Staff Report

Re: Petition PLNHLC201-00851, Relocation of 658 E. 600 South

RELOCATION OF A CONTRIBUTING STRUCTURE IN A LOCAL HISTORIC DISTRICT

PROPERTY ADDRESS: 658 E. 600 South

1904 Residential Structure

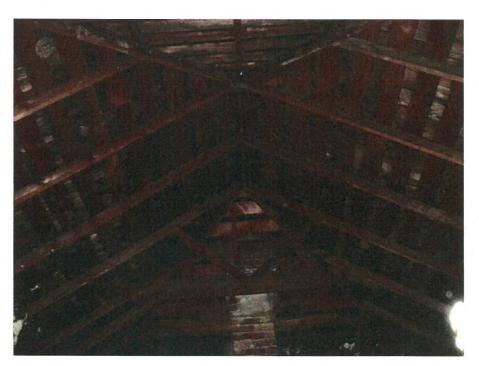
Roof framing and un-reinforced brick chimney

Chimney requires bracing and the roof is sagging behind the chimney
